# Access Compliance Report Public Rights-of-Way (Curb Ramps)

| Main Street: MARTHA_ANN_DR              |                                                                   | Cross Street: PIEDMONT_AVE |                                         | Location:       | E  |
| ADA ID: RPAT211206110816                | Ramp Type:Type 1 - Perpendicular Diagonal Initial Pass/Fail: Fail |                            | Overall Compliance: No                  | Severity Score: | 15 |

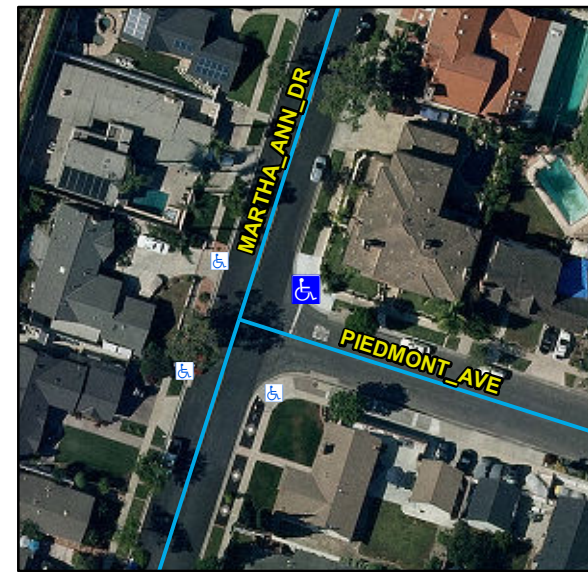
| Compliance | Description                           | Data | Compliance | Description                   | Data |
|------------|---------------------------------------|------|------------|-------------------------------|------|
| No         | Ramp Run Slope (%)                    | 8.4  | N/A        | Flare Slope LT (%)            | N/A  |

**Remove & Replace Curb Ramp With Two New Directional Ramps or Equivalent.**

**R304.2.2, STD 1115**
